95B.III – Macan Rear Lid Does Not Open/Close

Figure 1 - Rear locking bar (Circled)

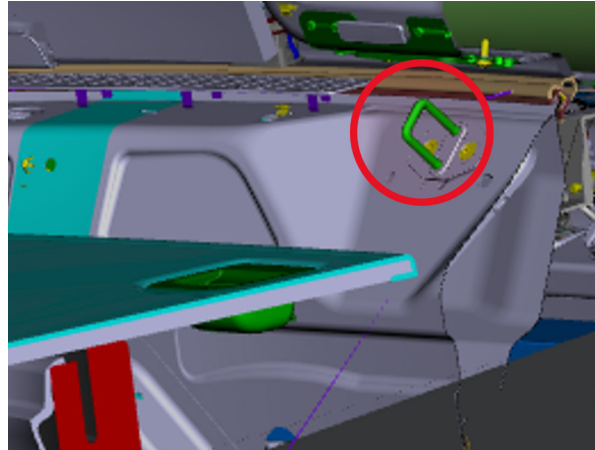
The condition described above can occur if the placement of the locking bar in the 95B.III Macan is set too high causing contact too soon (See Figure 1).

Adjust rear locking bar (the striker plate) down one 'index' level (Refer to Figure 2) and test to validate the repair successfully resolves the closing operation issue.
